GOVERNMENT - INDUSTRY DATA EXCHANGE PROGRAM		
PROBLEM ADVISORY		
1. TITLE (Class, Function, Type, etc.) Nickel Plated Kovar Lids		2. DOCUMENT NUMBER FV5-P-18-0001

3. DATE (DD-MMM-YY) 30-JAN-18
4. MANUFACTURER AND ADDRESS International Rectifier, HiRel Products 205 Crawford Street Leominster, MA 01453	5. PART NUMBER Various	6. NATIONAL STOCK NUMBER Not Applicable

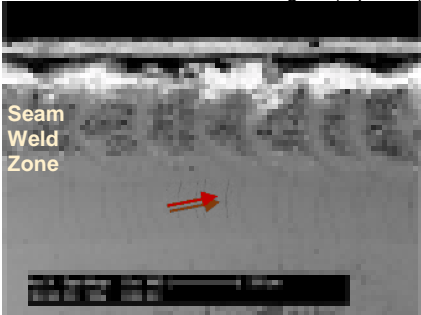
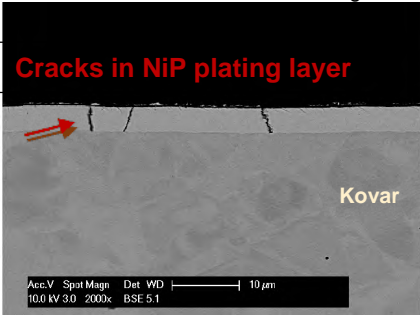
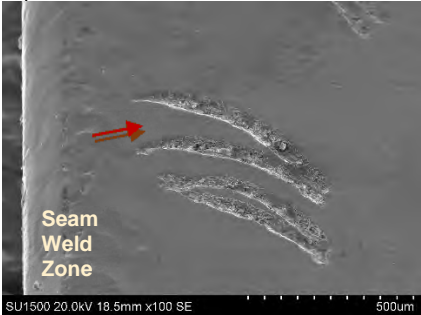
19. PROBLEM DESCRIPTION / DISCUSSION / EFFECT International Rectifier has identified that semiconductor devices that are seam welded with electroless nickel (NiP) plated Kovar lids can leak after exposure to MIL-STD-750, TM1041, salt atmosphere. This discovery was made irrespective of the fact that hermetic seal testing is not required following Salt Atmosphere for semiconductor devices (reference MIL-PRF-19500, Table E-VII, group C4). Failure analysis revealed hermetic seal leaks in the seam weld region. High magnification examination revealed the formation of micro cracks in the NiP plating at the seam weld that allowed salts to deposit and corrode through the underlying Kovar metal. Refer to image 1, 2 and 3 below for exhibit cracks in NiP.		
Image 1 Cracks in NiP at seam weld region (top view)	Image 2 Cross sectional view of seam weld region	Image 3 Top view of salt corrosion in Kovar

20. ACTION TAKEN/PLANNED In order to improve the robustness of IR semiconductor devices against corrosive environments or substances, an interlayer of electrolytic nickel will be added between the lid's Kovar base metal and external electroless nickel. Electroless nickel that contains 10 +/-2% phosphorus is brittle and can crack during the seam weld process. Electrolytic (Ni) nickel is more ductile than electroless (NiP) nickel and will act as a barrier to the Kovar base metal; hence making the product more robust. Implementation of the new Kovar lid plating is planned beginning March 2018.		
This Problem Advisory has been coordinated with DSCC-VQE and NASA prior to its release.		
Continued on page 2
